Project	IEEE 802.16 Broadband Wireless Access Working Group < http://ieee802.org/16 >	
Title	Proposal for updating 802.16g standard architecture reference model	
Date Submitted	2006-01-05	
Source(s)	Philip Barber Zou Lan Fu Yan Huawei Technologies	Mailto: zlan@huawei.com
Re:	Contribution on IEEE802.16g -05_008r2	
Abstract	This contribution proposed to update the system architecture reference model of 802.16-2004. And remove the corresponding description in 16g.	
Purpose	Adoption	
Notice	This document has been prepared to assist IEEE 802.16. It is offered as a basis for discussion and is not binding on the contributing individual(s) or organization(s). The material in this document is subject to change in form and content after further study. The contributor(s) reserve(s) the right to add, amend or withdraw material contained herein.	
Release	The contributor grants a free, irrevocable license to the IEEE to incorporate material contained in this contribution, and any modifications thereof, in the creation of an IEEE Standards publication; to copyright in the IEEE's name any IEEE Standards publication even though it may include portions of this contribution; and at the IEEE's sole di

Figure A – Network Reference Model

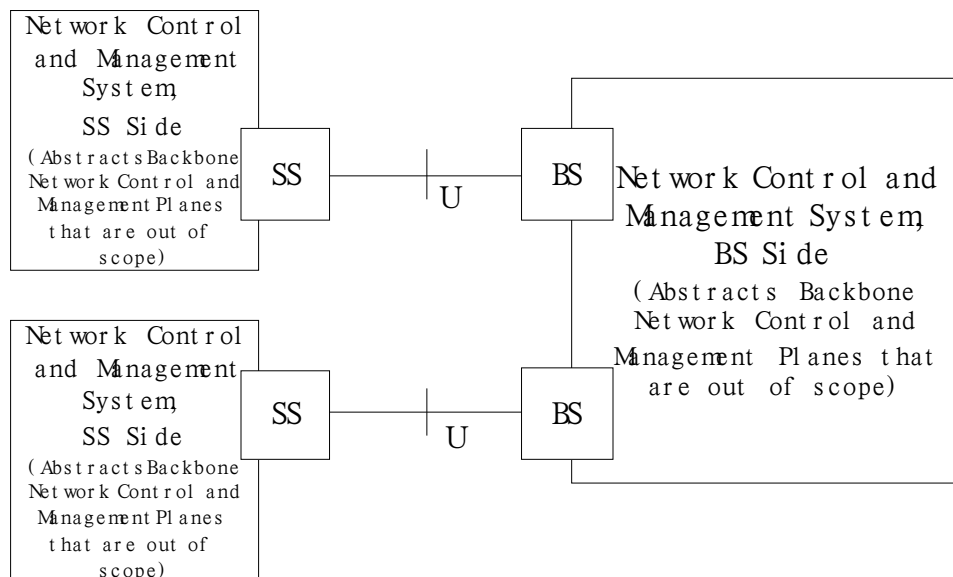
The Figure A describes a network reference model along with the interfaces that are within the scope of this specification. Multiple SS or MS maybe attached to a BS. ~~The SS communicate to the BS over the U interface using a Primary Management Connection or a Secondary Management Connection. MS typically only utilize the Primary Management Connection over the U interface for management and related control functions.~~ **SS or MS communicate to the BS over the U interface using a Primary Management Connection, a Basic Management Connection or a Secondary Management Connection.**

Figure B Illustration of BS side Network Control and Management System

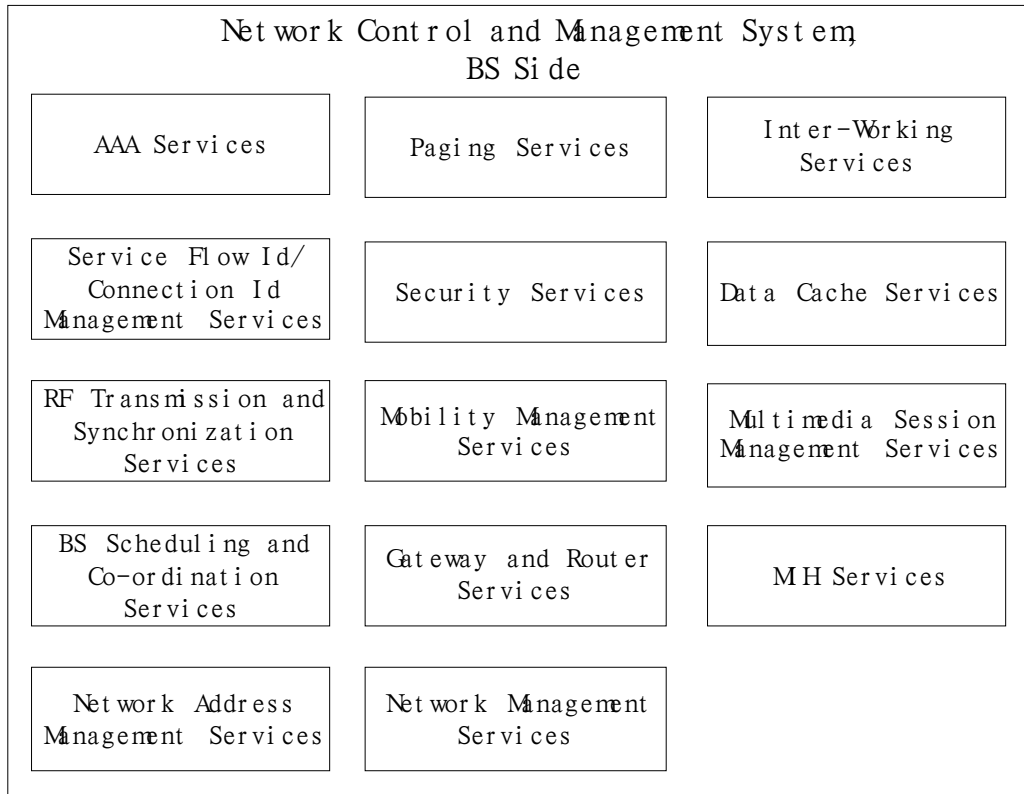
~~This abstraction is detailed in Figure y to show the different functional entities that make up such a Network Control and Management System. These entities may be centrally located or distributed across the network. The exact functionality of these entities and their services is outside the scope of this specification but shown here for illustration purposes and to better enable the description of the management and control procedures.~~

This abstraction is detailed shown the different functional entities that make up a Network Control and

Management System. For different network elements, the corresponding NCMS functions are also different. The exact functionality of these entities and their services is outside the scope of this specification but shown here for illustration purposes and to better enable the description of the management and control procedures. The illustrated BS side NCMS functions are shown in Figure B.

Figure C Illustration of SS side Network Control and Management System

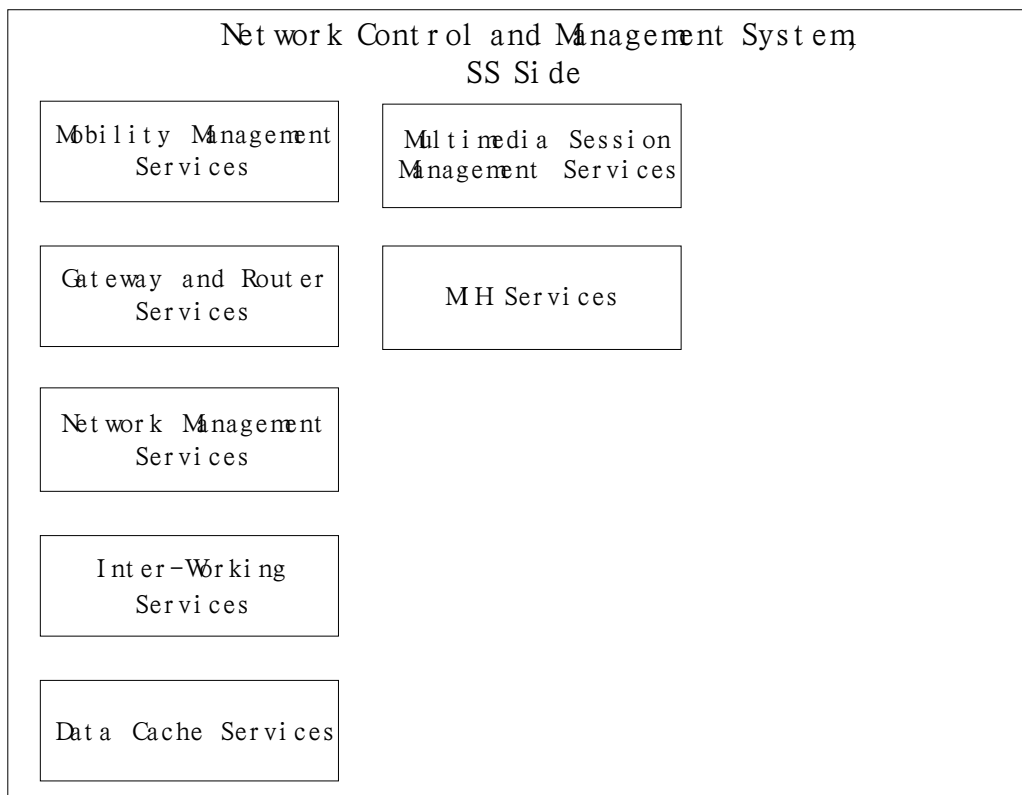
The illustrated SS side NCMS functions are shown in Figure C.

Figure D System Architecture Model

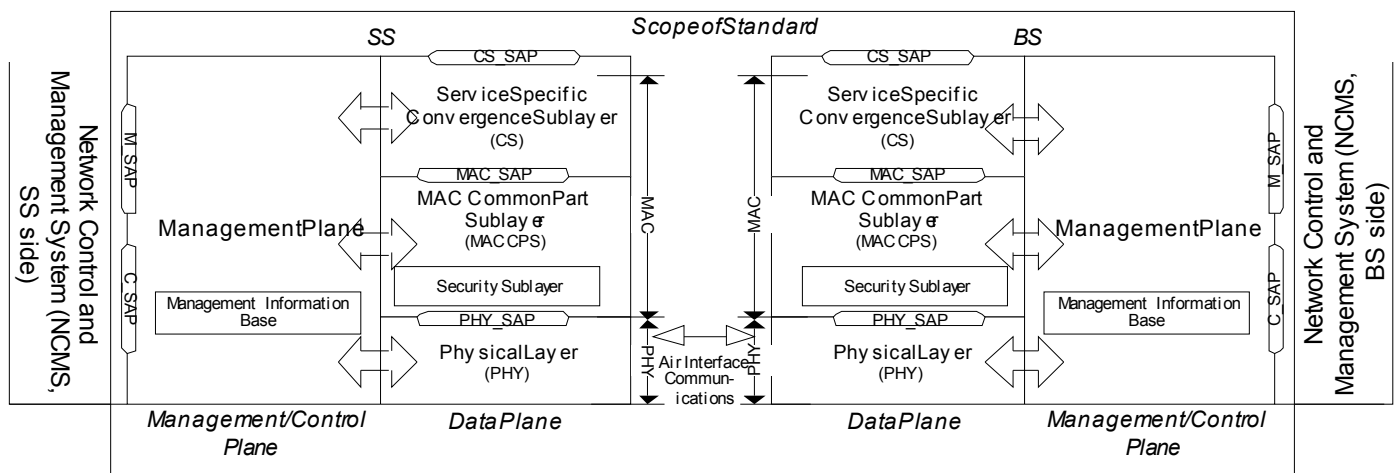
The system architecture is shown in Figure D.

This interface is a set of Service Access Points (SAP) between SS/MS and NCMS and is represented in the Figure D. It is decomposed into two parts: the Management SAP is used for Management plane primitives alone and the Control SAP is used for Control plane primitives that to support handovers, security context management, radio resource management, and low power operations (such as Idle mode and paging functions). The primary goal of such an interface is to ensure protocol separation.

This interface is a set of Service Access Points (SAP) between BS and NCMS and is represented in the Figure D. It is decomposed into two parts: the Management SAP is used for Management plane primitives alone and the Control SAP is used for Control plane primitives that to support handovers, security context management, radio resource management, and low power operations (such as Idle mode and paging functions). The primary goal of such an interface is to ensure protocol separation.
